Service Bulletin

NO. 348

SOUTH BEND 27, INDIANA

REVIEW OF ENGINE OIL RECOMMENDATIONS

Fig. 3

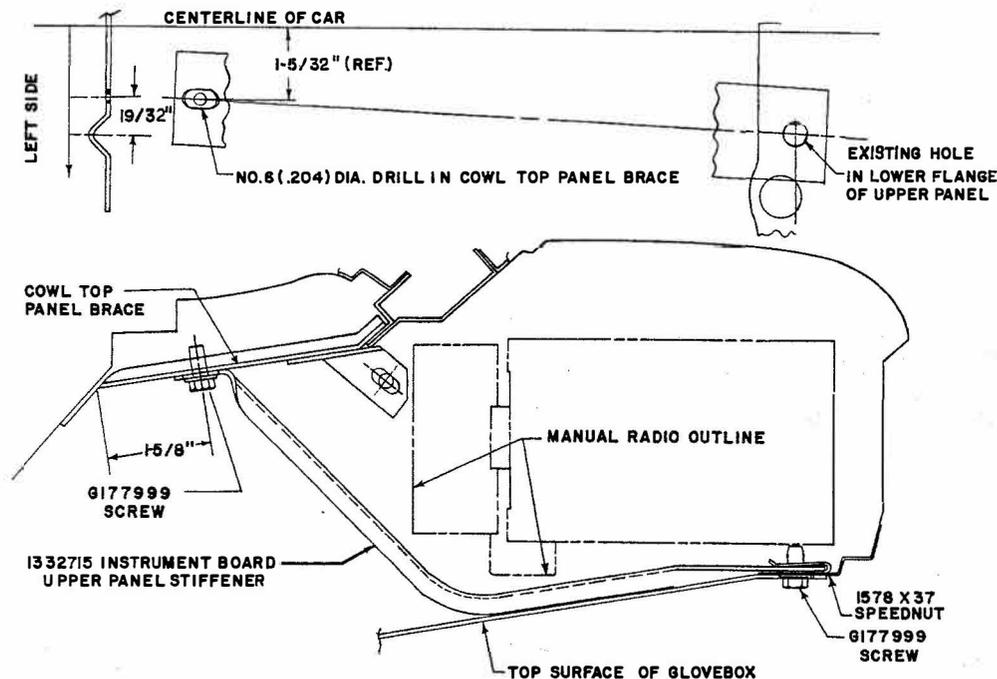
To provide increased stability of the instrument board panel, a stiffener brace entered production starting with Serial Nos. 59S-80105 and 59V-30318.

The brace, installed as shown in Fig. 3, may easily be installed in cars before the above serial numbers. The brace will reduce instrument board movement and assist in preventing squeaks, buzzes and rattles caused by excessive instrument board movement.

To install, first remove the glove compartment box. It is not necessary to remove the radio in cars so equipped. Place the flat end of the brace on the upper opening flange for the glove box at the first hole to the left of the door catch and install the Screw, Part No. G177999, and Speednut, Part No. 1578X37. Using the brace as a template or the dimensions given in Fig. 3, mark and drill a 3/16" hole in the cowl top panel brace and install Screw, Part No. G177999. Install the glove compartment box.

FIG. 4

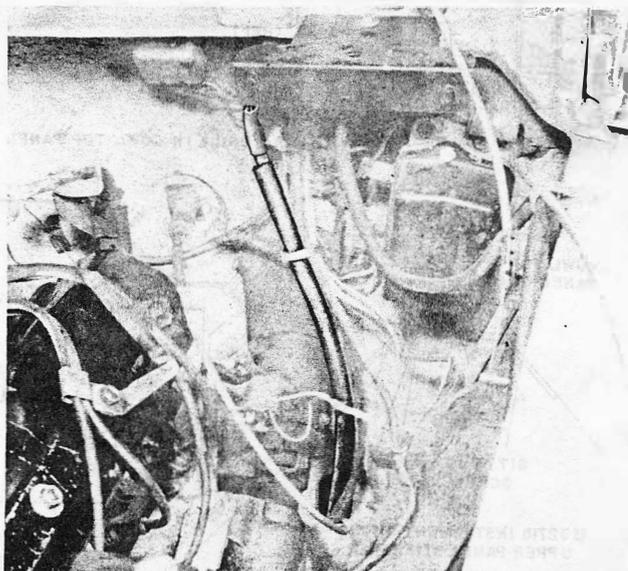
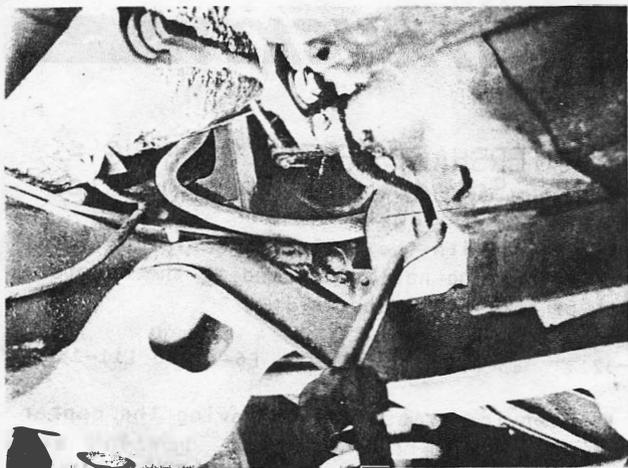
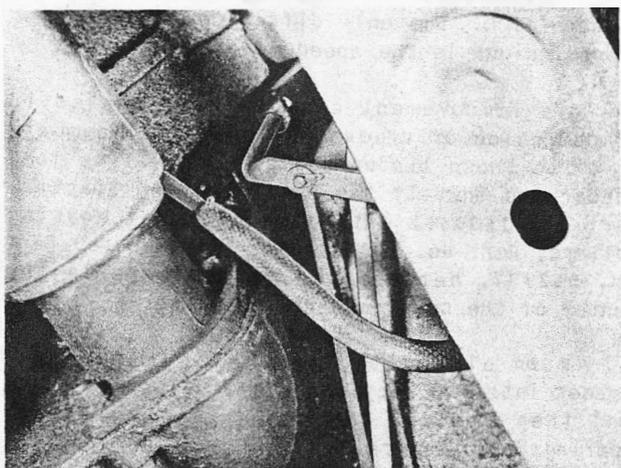
To prevent possible interference between the starter motor cable and the accelerator linkage, the starter switch-to-starter motor cable has been lengthened and rerouted on 59V Lark Models. This change entered production with Serial No. 59V-26047.

The improved routing of the cable is shown in Figure 4, 5 and 6.

Note cable routed through
body hold-down bracket

Fig. 5 - Car with OD and Power Steering. Clutch Operating Shaft removed to show cable.

Fig. 6 - Car with Automatic - Note position of Cable in respect to throttle linkage.

FIG. 7

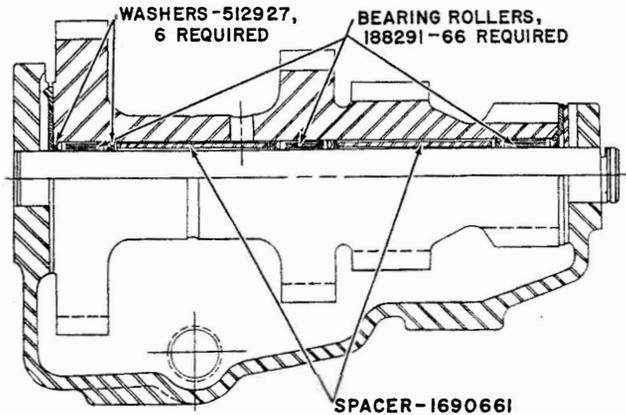
Beginning with the following serial numbers, a center bearing has been added to the countershaft of the T90B transmission.

This improvement can be incorporated in transmission of trucks having serial numbers prior to those listed above. Remove the long spacer and install two short Bearing Spacers, Part No. 1690661 with 22 additional bearing rollers, Part No. 188291, and two washers, Part No. 512927, between the two spacers in the center of the countershaft. See Fig. 7.

As an alternate, you may cut the long spacer into two sections 2.079" (2-5/64") long and then install the necessary additional bearings and washers.
